<b>T.I. no.:</b> 2023-23 <b>Updated:</b> -	<b>Topic:</b> Pump Bypass Repair Set
---	--------------------------------------

<b>Date:</b> 24.11.2023	<b>Priority</b> <input type="radio"/> High <input type="radio"/> Medium <input checked="" type="radio"/> Low	<b>Need for action</b> As soon as possible On next visit to the machine FYI only
<b>Affected machines:</b> Schaerer Barista		
<b>From serial number:</b> -		
<b>Start date:</b> immediately

Figure 2: Installation of repair set

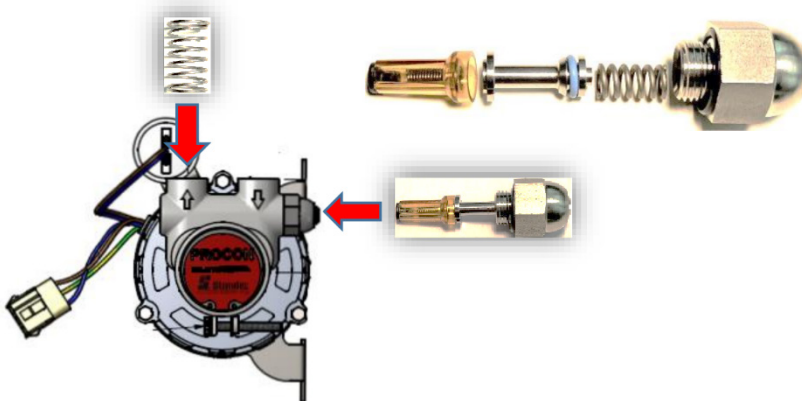
A repair set is now available for the pump head of the espresso pumps of the machines named above.

The repair set can be used to avoid replacing a complete pump or pump head if the following fault patterns occur:

- Leakage at the adjusting screw or cap nut
- Pump pressure cannot be set correctly.
- Pump pressure fluctuates heavily.

We recommend applying a light coat of the grease for sealing rings (Molykote 111 / article number 33.2179.9000) to the two O-rings when installing the repair set.
